# AC Hotel Portland

## Level III Final Site Plan Application

**RE: AC Hotel Portland  
Response to Staff Review Comments**

Sheet No: **C1.0**  
Sheet 4 of 17

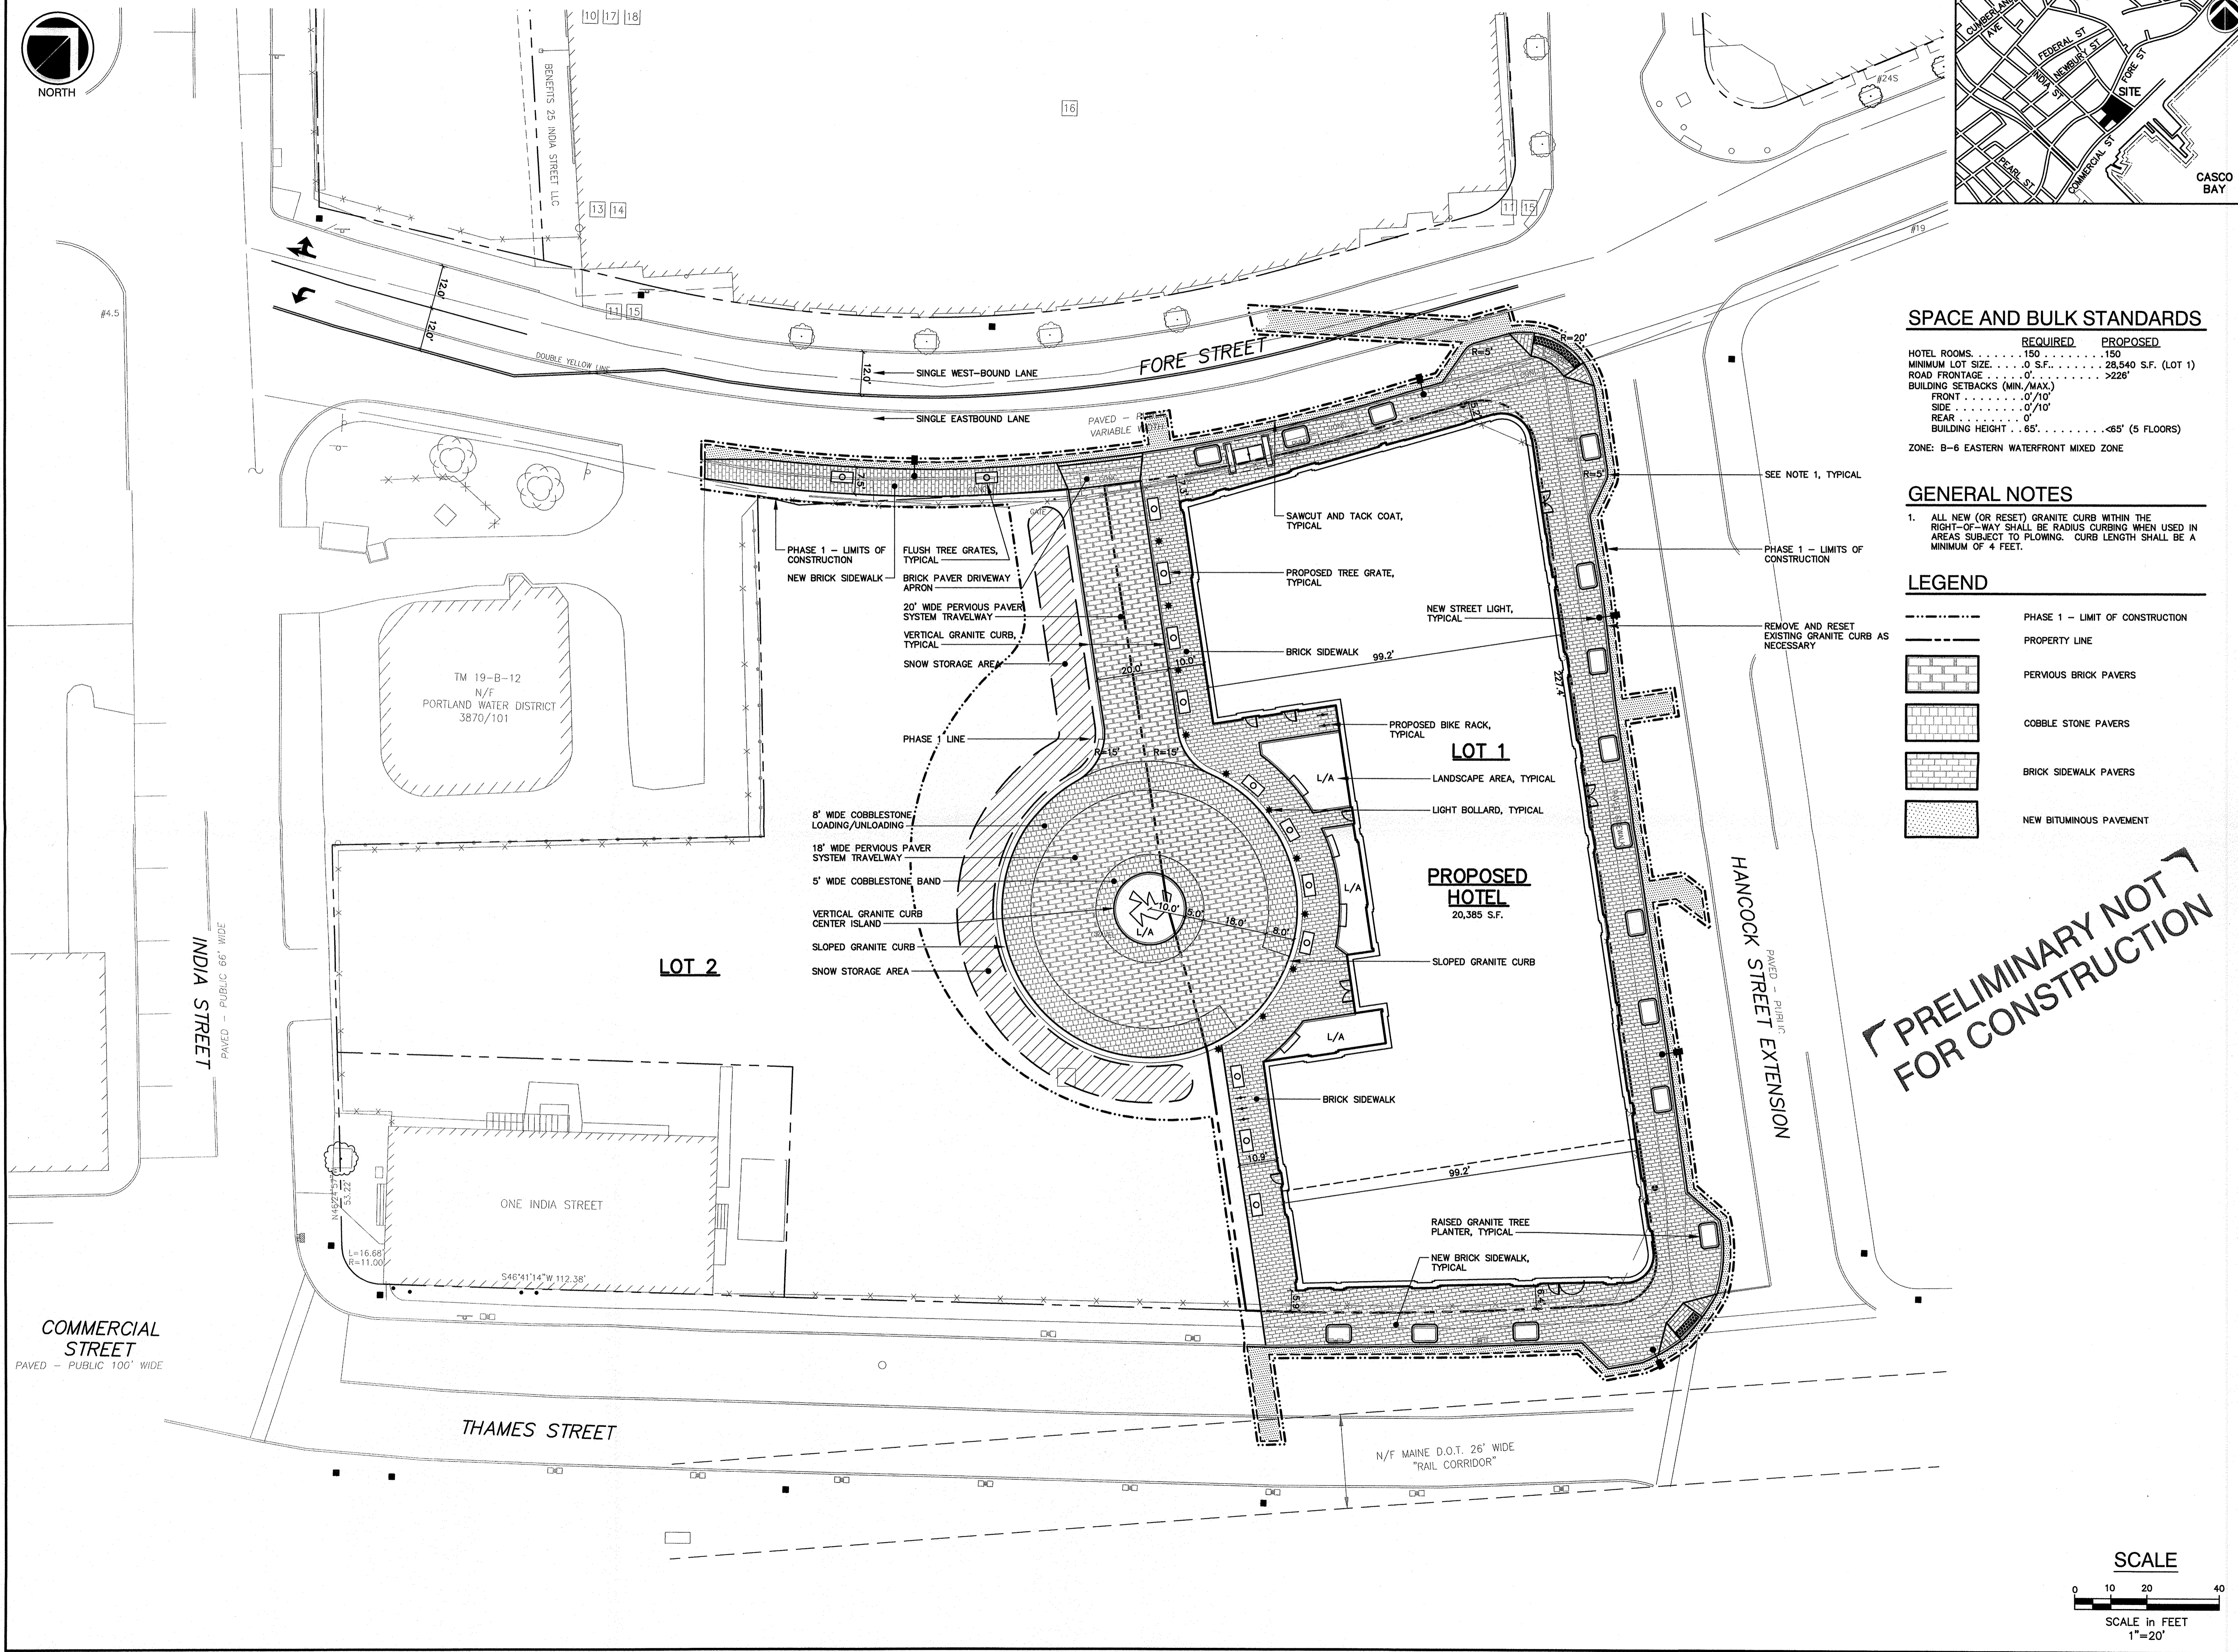
1. Sheet C1.0 – Site Plan, the applicant is showing a brick driveway apron and has asked where the code states an asphalt drive is required. It is my understanding that the City Council in 2000 passed such a material policy and that any change from this policy requires Council authorization.

**RESPONSE: Sheet C1.0 has been revised to include additional sidewalk repair and Sheet C1.2 has been revised to include a proposed drain manhole.**
